Metro Inner Development Assessment Panel Agenda

**Part B – Item 5.1 - LOT 800 (NO. 29-33) NORTHWOOD
STREET, WEST LEEDERVILLE – THREE-STOREY CHILD
CARE PREMISES AND OFFICES - AMENDMENTS TO
DAP/20/1911 (DA20/0380 AND DA24-210)**

**Form 2 – Responsible Authority Report
(Regulation 17)**

Figure 1 — 2021 Approved Landscaping Plan (Northwood Street Elevation)

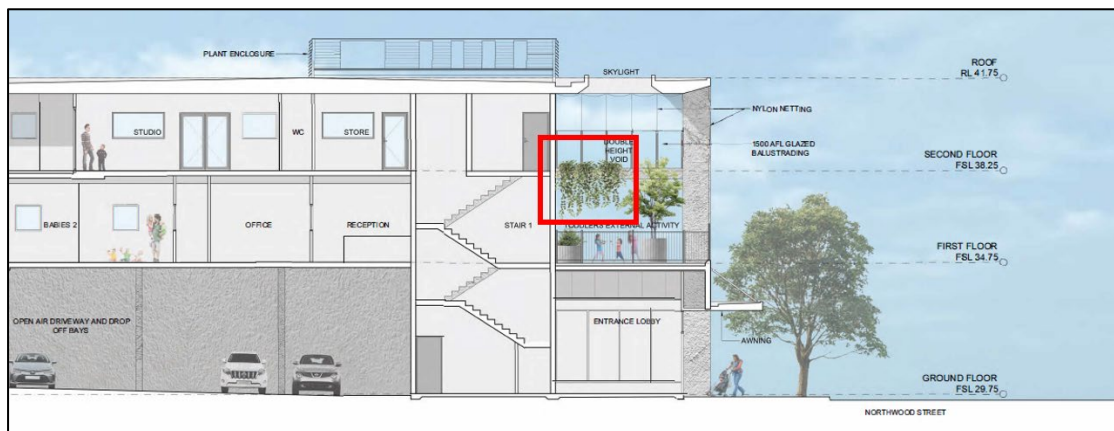
The below 2021 approved landscaping plan (Figure 1) and sectional drawing (Figure 2) indicate the location and appearance the cascading landscaping planter beds.

The applicant has justified the omission of the two cascading planter beds on the basis that they cannot be accessed to allow ongoing care and maintenance.

Figure 4 — As-Constructed Roof Plan (Continuous Shade Cloth)

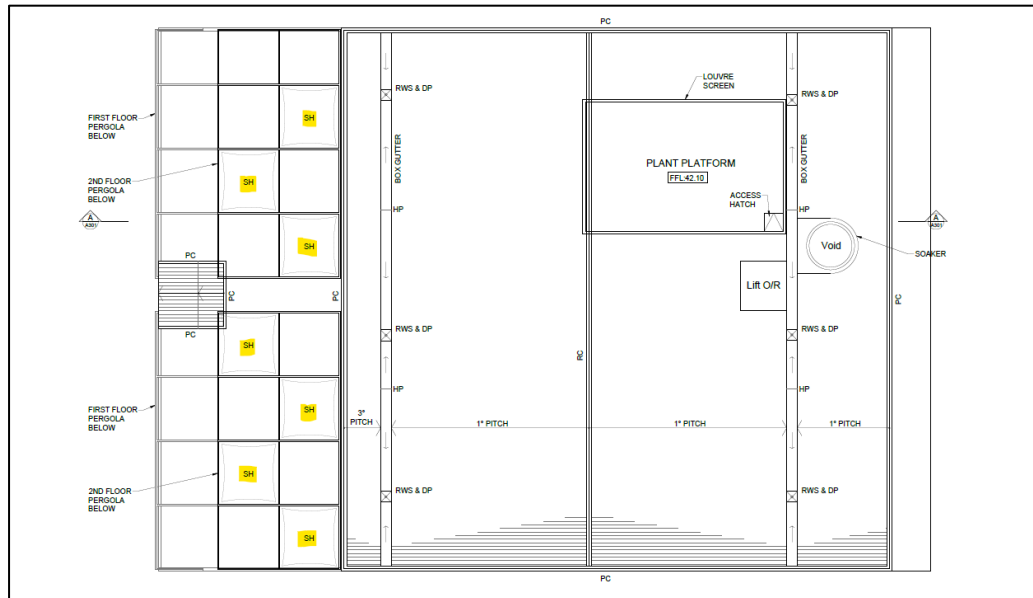
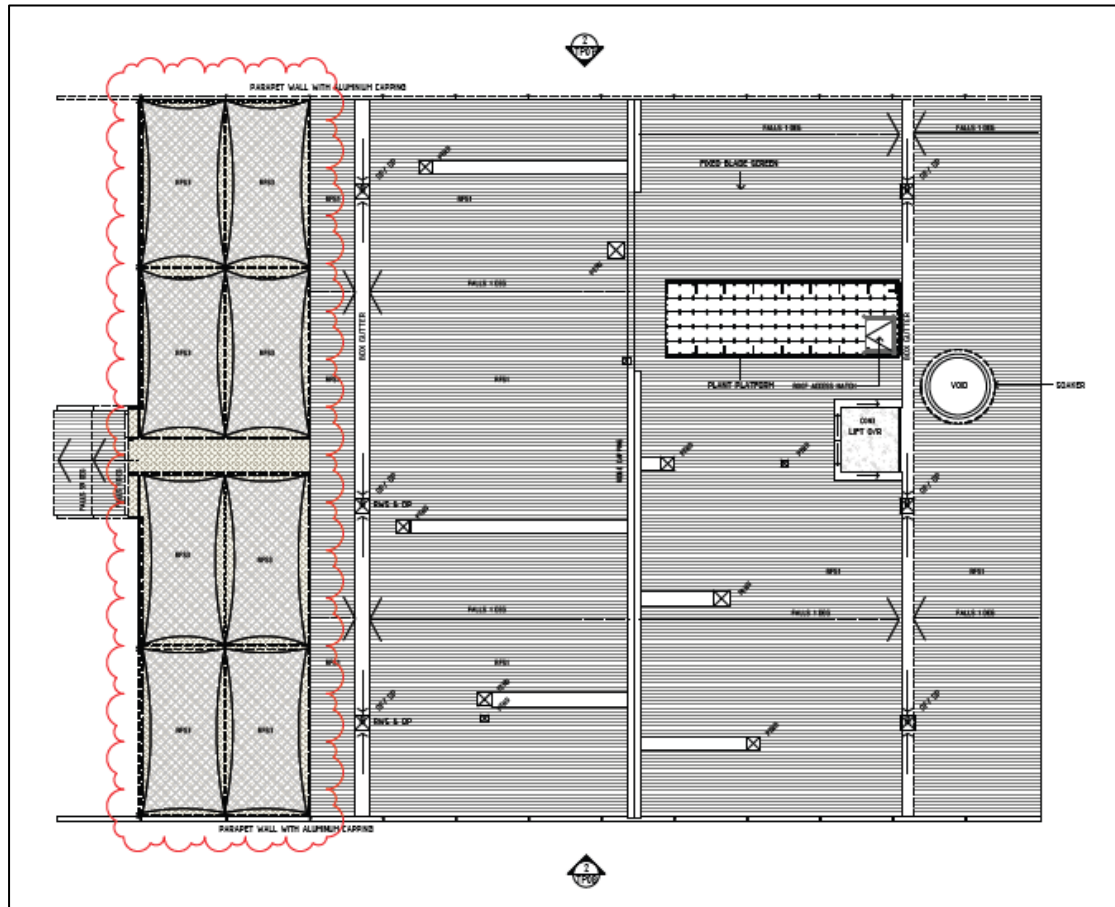
In contrast, the amended roof plan (Figure 4) reflects the as-constructed development; being shade cloth coverage across the entire steel-frame structure, eliminating all openings and creating a fully shaded canopy.

This modification results in a significantly greater perceived bulk and mass, particularly given the play area's elevated position, the relatively limited setback to Pether Lane, and the combined presence of the shade structure, fencing and overhead framing at upper-floor level (Figures 5 and 6).

of bulk where practicable. Accordingly, it is recommended that the DAP, if it is minded to approve this element, only do so subject to a requirement for the applicant to submit a revised shade design (supported by a detailed outcome-based assessment of the shade requirements) demonstrating a built-form outcome that achieves adequate sun protection while reducing visual bulk to an acceptable level.

18. *Within 60 days of the date of this approval, the applicant must submit to the Town of Cambridge a revised shade structure design, supported by a shade analysis, demonstrating that the design:*
- a. reduces visual bulk when viewed from Pether Lane and adjoining residential properties; and*
 - b. provides adequate sun protection for children in accordance with relevant health and safety requirements.*

Figure 9 — Amended Slat Screen Elevation (Upper Levels Only)

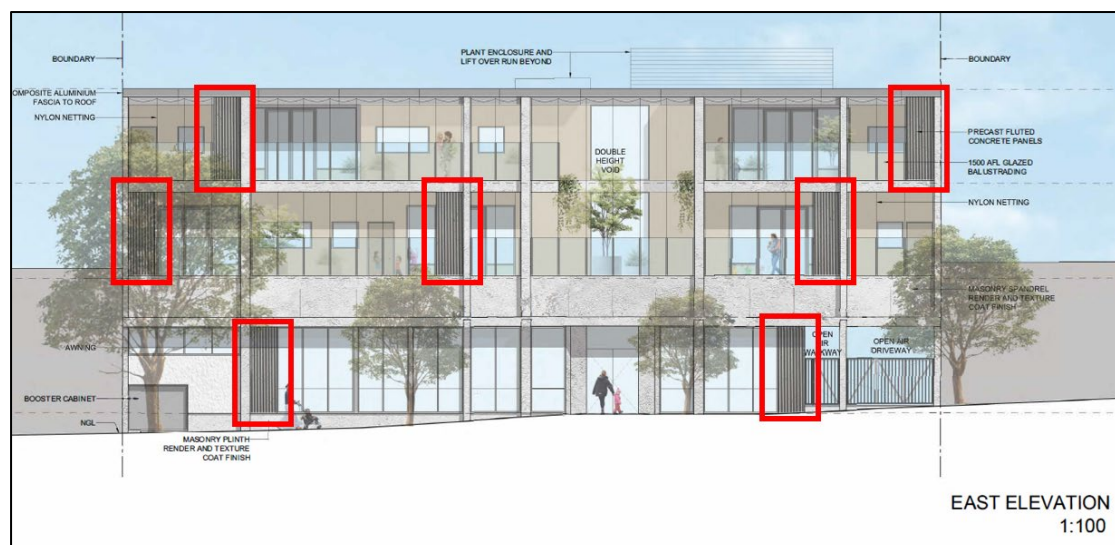
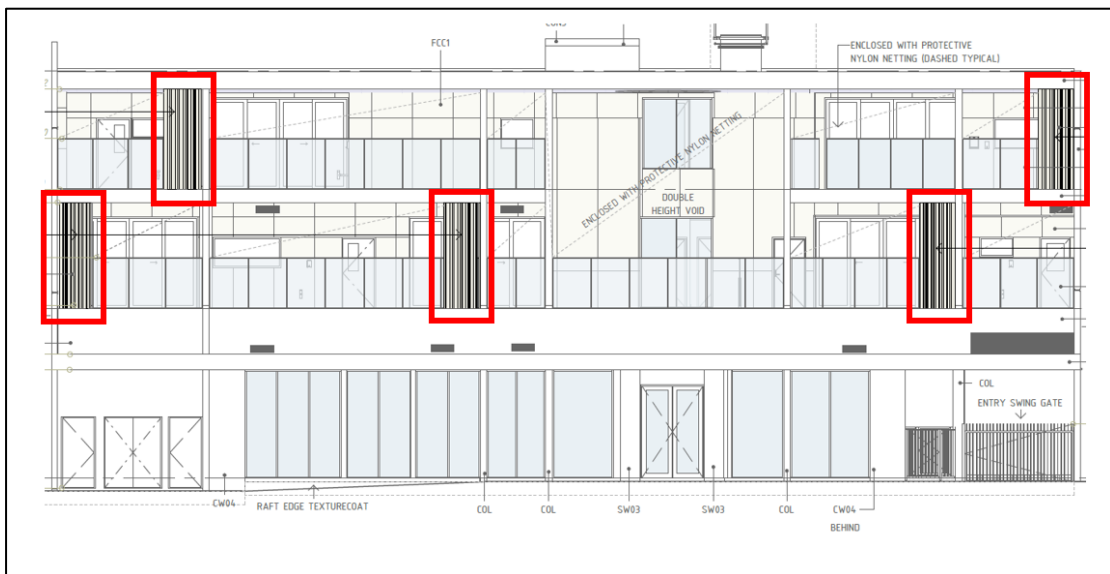
The 2021 DAP-approved eastern elevation facing Northwood Street (Figure 7) incorporated seven fluted concrete panels distributed across the ground, first, and second floors. These panels were an integral architectural feature, contributing to:

However, the development as constructed does not include the concrete fluted panels originally shown on the approved plans (Figure 8). The resultant Northwood Street elevation presents as a largely flat and visually uniform façade, with minimal depth or variation at ground level and limited articulation at the upper levels.

The amended proposal introduces five aluminium slat screens on the first and second floors (Figure 9). These screens provide some degree of texture and modulation at the upper levels; however, no articulation or equivalent treatment is proposed at ground level. This produces a dominant and unvaried street interface where the base of the building lacks definition, depth, or human-scale elements.

When assessed on its merits, the proposed façade treatment does not fully satisfy the design principles of SPP 7.0 – Design for the Built Environment, particularly:

Accordingly, the Town partially supports the amended façade proposal, subject to the imposition of a condition requiring the applicant to provide an amended ground-floor façade treatment that incorporates depth, layering and visual interest appropriate to a street-facing elevation.

19. *Within 28 days of the date of this approval, the applicant must submit to the Town of Cambridge a ground-floor articulation plan for the Northwood Street elevation demonstrating adequate depth, layering and visual interest at the pedestrian level, to the satisfaction of the Town of Cambridge.*

Figure 16 — 2021 Approved Stairwell Cladding (Image 3 – North Elevation)

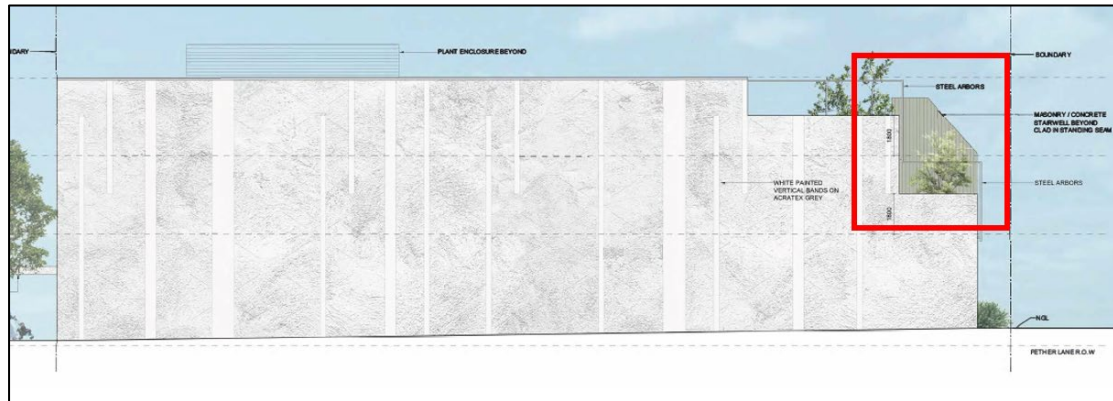
The 2021 approval required metal cladding to be applied to the stairwell walls on both the first and second floors, including the side walls of the internal balcony circulation areas (Figures 14, 15 and 16). These surfaces are visible from Pether Lane and adjoining properties. The approved cladding was intended to be finished in an earthy green or grey tone to complement the architectural palette and provide a consistent, high-quality material expression.

The as-constructed development deviates from this requirement, by way of the following.

In response to the DRP's feedback, the amended plans propose that the first-floor western stairwell wall be repainted in "Timeless Grey" (a low-sheen finish), while retaining the exposed concrete side walls and the existing zincalume cladding to the second-floor angled wall.

- these walls primarily face inward toward balcony and circulation spaces rather than the public realm;
- they are secondary elements with limited visibility from Pether Lane, where they are partly screened by fencing, planting and balcony structures;
- exposed concrete is an inherently durable, low-maintenance material; and
- finishing these internal side walls in metal cladding would not materially improve the public-facing streetscape outcome.
